Harris Park Station Upgrade

Determination Report

**Transport Access Program
Ref- 5197389**

June 2016

Figure 2 Schematic of the revised Proposed Activity

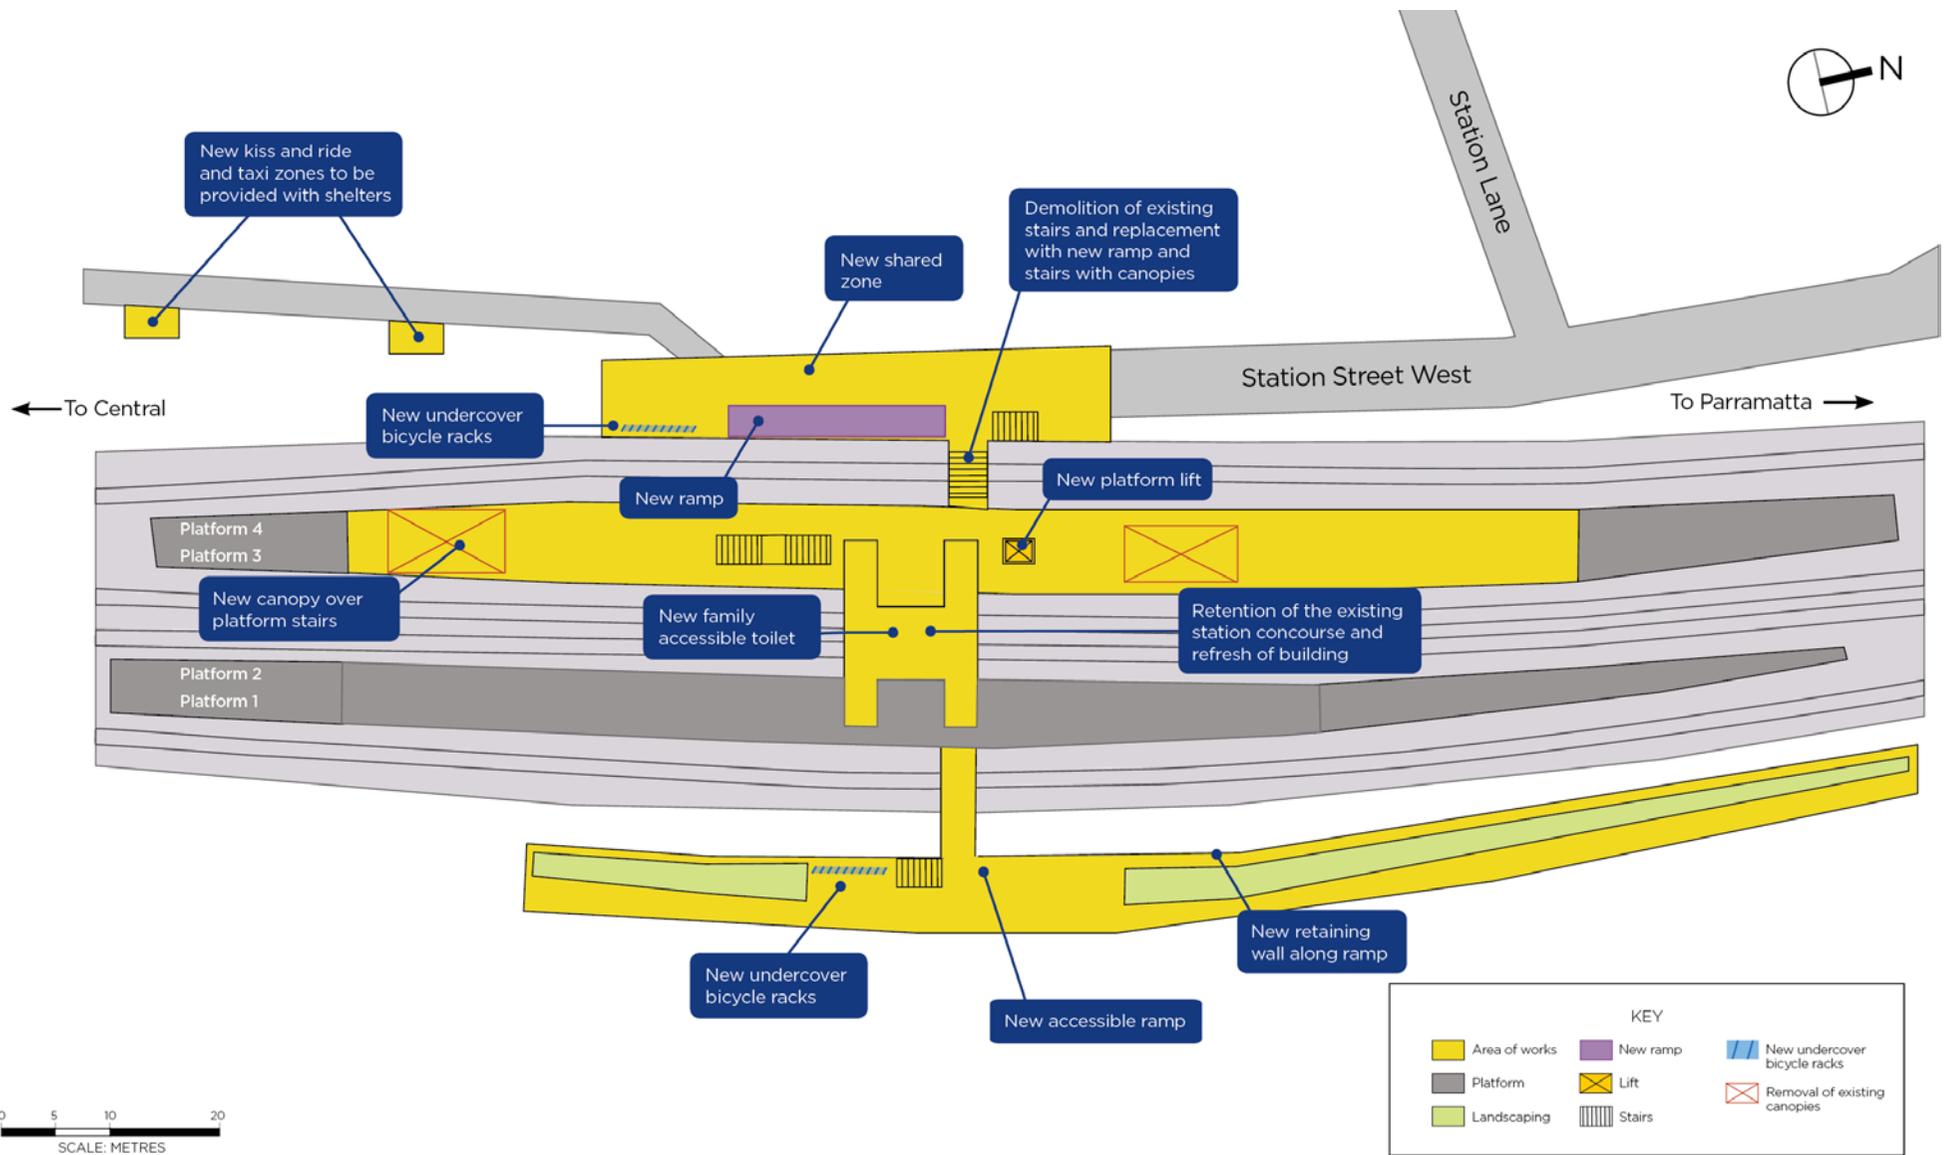
As a result of community feedback, and additional investigations regarding how best to provide value for money and improve access; a change in scope has been proposed. The key changes include:

- replacement of the proposed lift at the eastern station entrance with an accessible ramp
- removal of the proposed lift and canopies on platform 1/2 given the minimal current and future planned use of this platform for timetabled services. Customers would still be able to access the platform via the existing stairs during rail shutdowns, if required
- no platform regrading on platform 1/2.

In summary, the revised Proposed Activity would comprise Figure 2:

- retention and refresh of the existing station concourse including a new family accessible toilet
- new ramp and stairs at the western station entrance

- new ramp and stairs at the eastern station entrance
- installation of new canopies on stairs, platforms and station entrances for weather protection on platform 3/4

- installation of one new lift on platform 3/4
- upgrade of shared path from Station Street East to the station and a partial upgrade of the path between Cambridge Street and the station
